Docket Number:	15-AFC-02
Project Title:	Mission Rock Energy Center
TN #:	214394
Document Title:	Responses to CEC Staff's Data Requests 116 through 131 (Set 1B)
Description:	N/A
Filer:	M. Finn
Organization:	CH2M
Submitter Role:	Applicant Consultant
Submission Date:	11/7/2016 2:02:30 PM
Docketed Date:	11/7/2016

Responses to California Energy Commission Staff
Data Requests 116 through 131 (Set 1B)

Mission Rock Energy Center

DR121-1 - Page 1
Generator Tie-Line, Natural Gas Pipeline,
and Water Supply Pipeline
Disturbance Areas
 Mission Rock Energy Center
 Ventura County, California

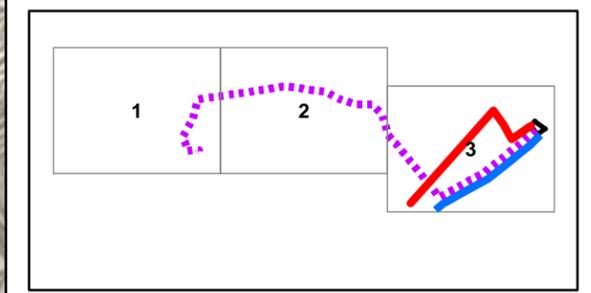
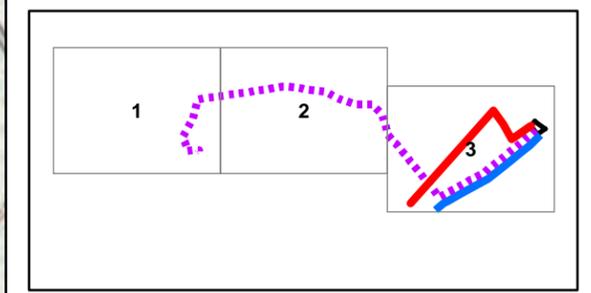
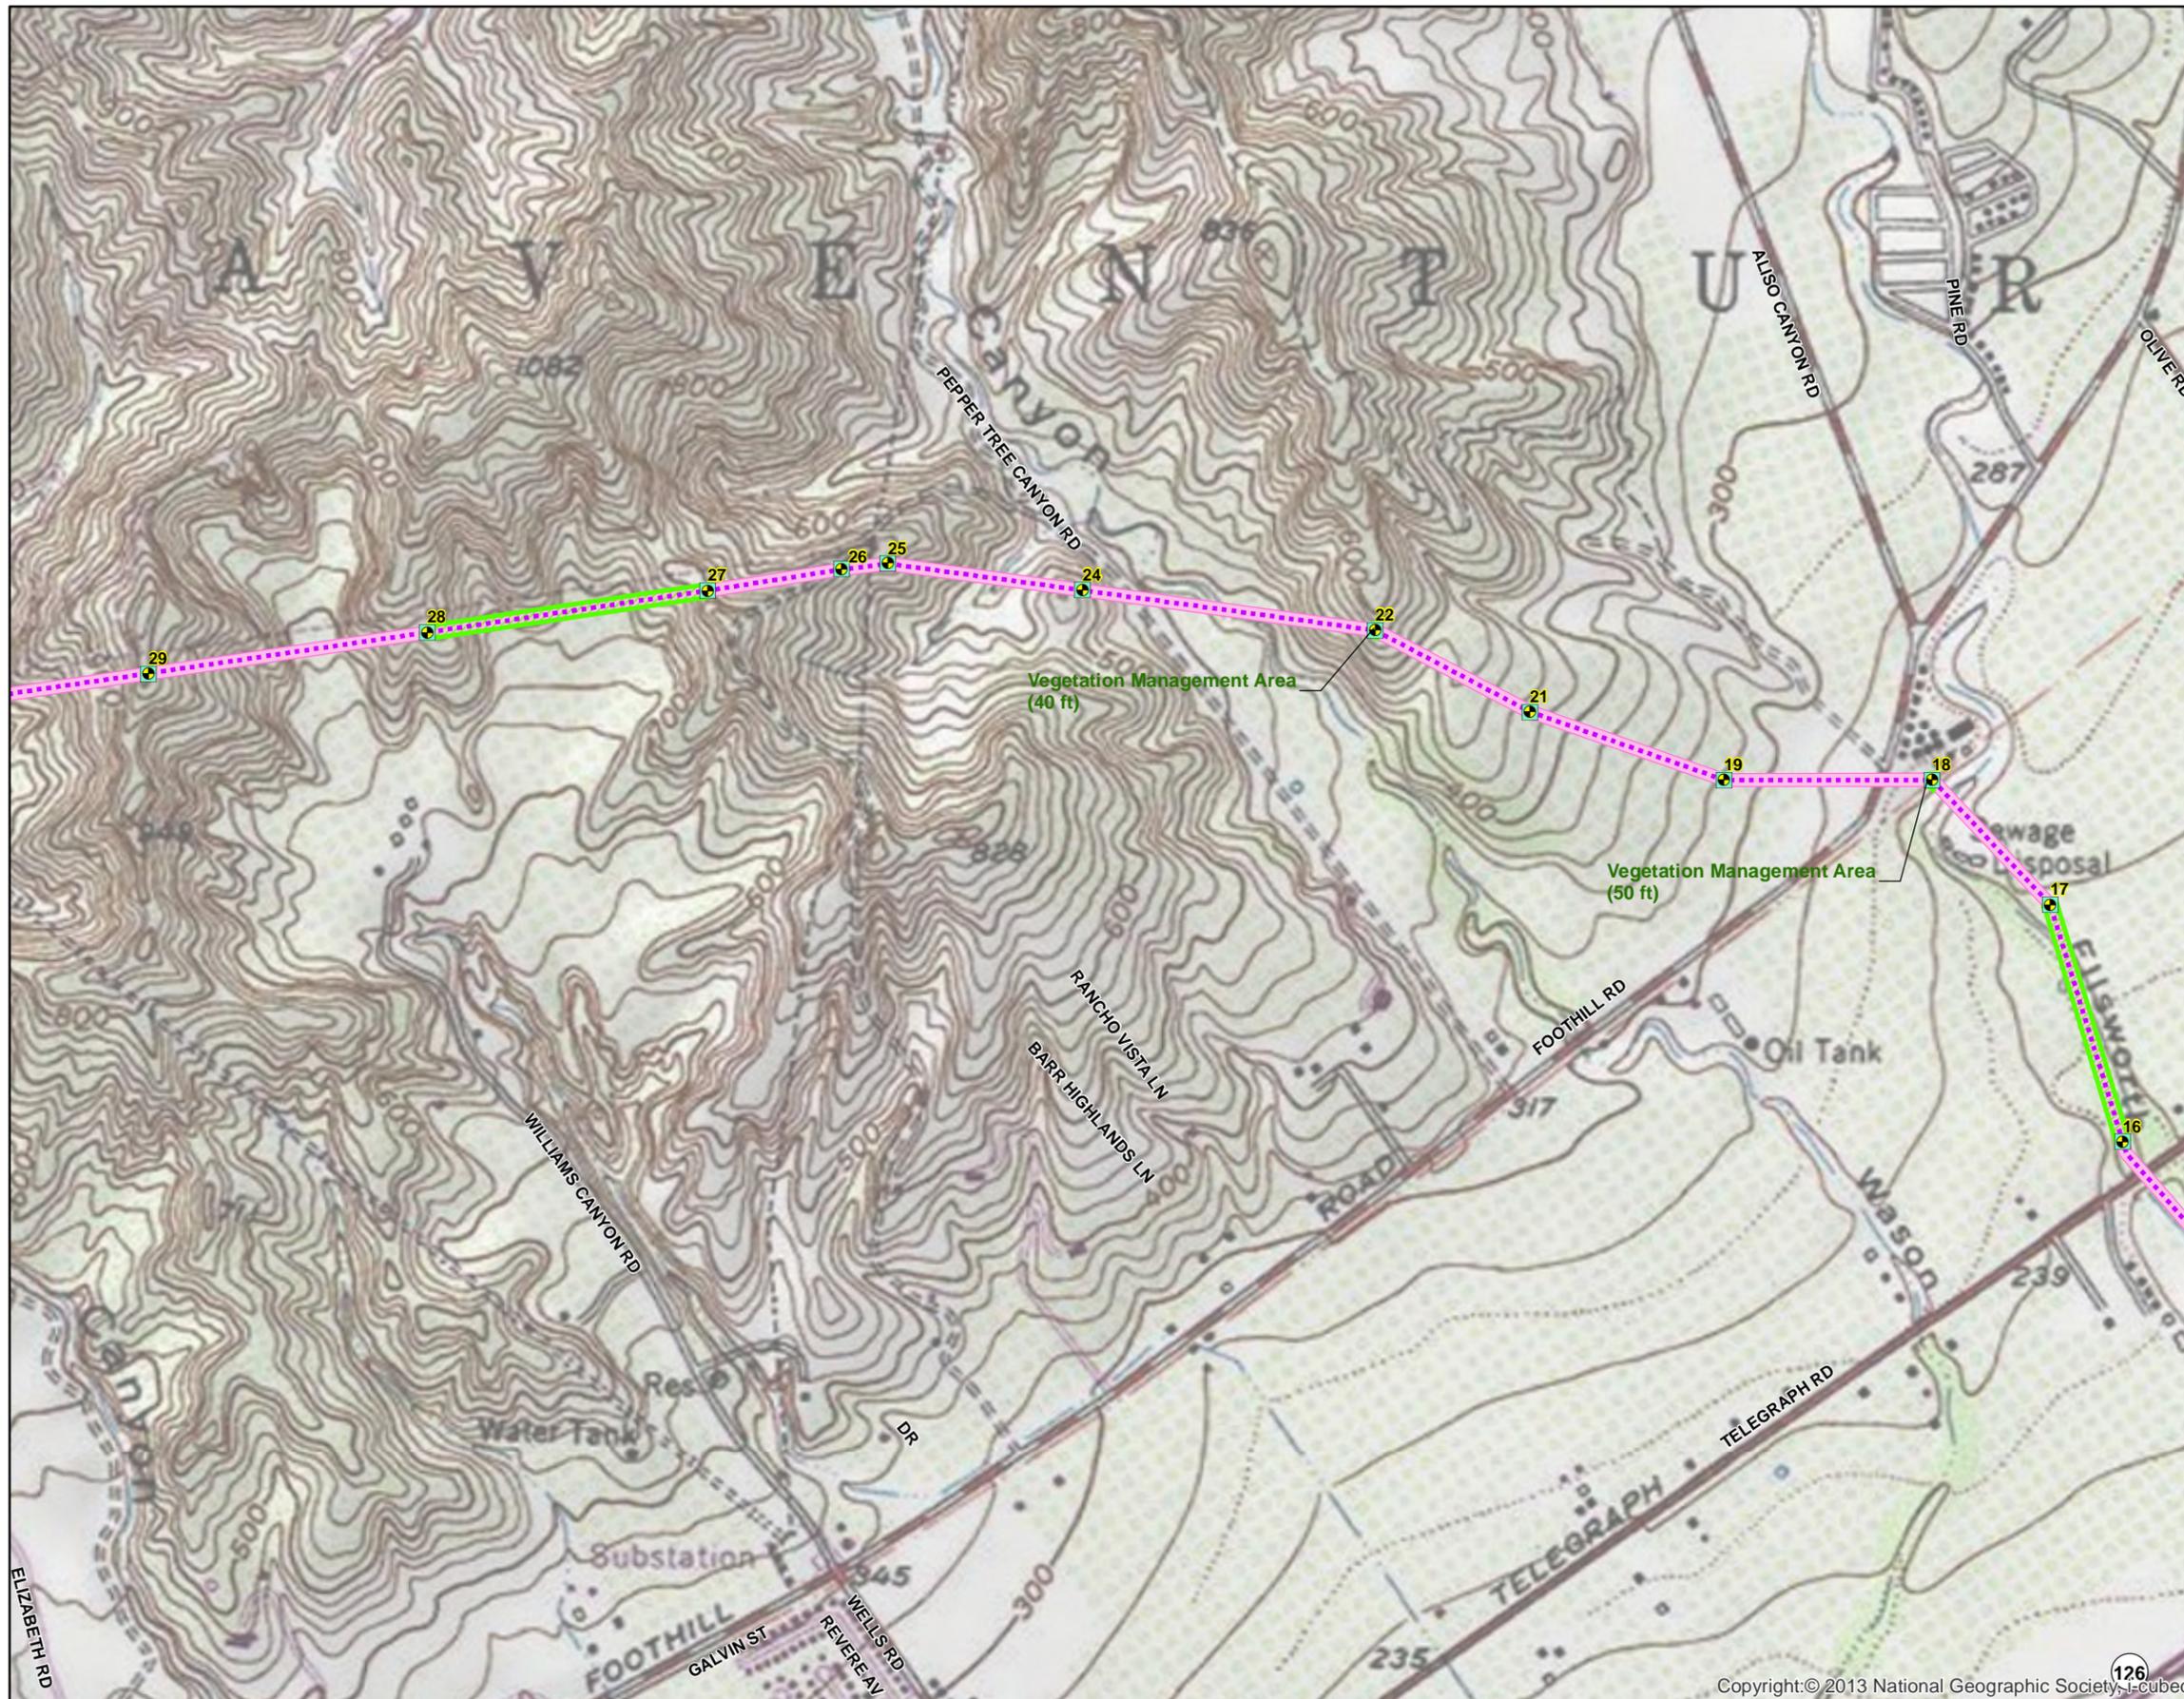
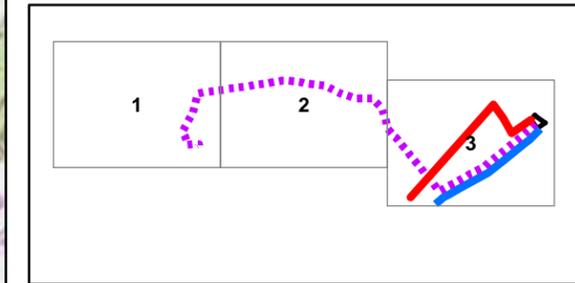
121. *Please provide the right-of-way width required for the generation tie-line (half and full right-of-way). Note any differences in right-of-way width requirements due to terrain or adjacent land uses or structures. Please map the right-of-way on aerials and a series of maps based on USGS 7.5-minute topographic maps enlarged to a scale of 1"=1,000 feet. Please provide the Geographic Information Systems shape files for the right-of-way. Please indicate areas of any new right-of-way versus existing right-of-way.*

123. *Please provide the amount of temporary area and permanent area disturbed for the generation tie-line and show the areas on aerials and also a series of maps based on USGS 7.5-minute topographic maps enlarged to a scale of 1"=1,000 feet for the following list items (a-d). Please also identify the temporarily and permanently impacted areas (size in acres) and please provide the Geographic Information System shape files for the following listed items:*

126. *Please provide the right-of-way width required for the new recycled water pipeline (half and full right-of-way). Note any differences in right-of-way width requirements due to terrain or adjacent land uses or structures. Please map the right-of-way on aerials and a series of maps based on USGS 7.5-minute topographic maps enlarged to a scale of 1"=1,000 feet. Please provide the Geographic Information Systems shape files for the right-of-way. Please indicate areas of any new right-of-way versus existing right-of-way.*

129. Please provide the amount of temporary and permanent area disturbed for the recycled water pipeline and show the areas on aerials and also a series of maps based on USGS 7.5-minute topographic maps enlarged to a scale of 1"=1,000 feet for the following list items (a-d). Identify the temporarily and permanently impacted areas (size in acres). Please provide the Geographic Information System shape files for the following:

131. Please provide the amount of temporary and permanent area disturbed for the natural gas pipeline and show the areas on aerials and also a series of maps based on USGS 7.5-minute topographic maps enlarged to a scale of 1"=1,000 feet for the following list items (a-d). Identify the temporarily and permanently impacted areas (acres) and please provide the Geographic Information System shape files for the following:

Response: The generator tie-line right-of-way is 75 feet wide (37.5 feet either side of the centerline). Figure DR121-1 shows the generator tie-line route at a scale of 1" = 1,000 feet, showing the right-of-way. The generator tie-line consists entirely of new right-of-way. Although the line parallels other, existing rights-of-way in certain locations, it does not use existing right-of-way.

Response: The entire width of the recycled water pipeline right-of way will be 30 feet. See Figure DR121-1 for a map at a scale of 1" = 1,000 feet showing the recycled water pipeline right-of-way.

Response: See Table DR129-1 and Figure DR121-1.

Response: See Table 131-1 and Figure DR121-1. Per Section 3.0 of the AFC, the gas pipeline trench will be 30 inches wide (2.5 feet).
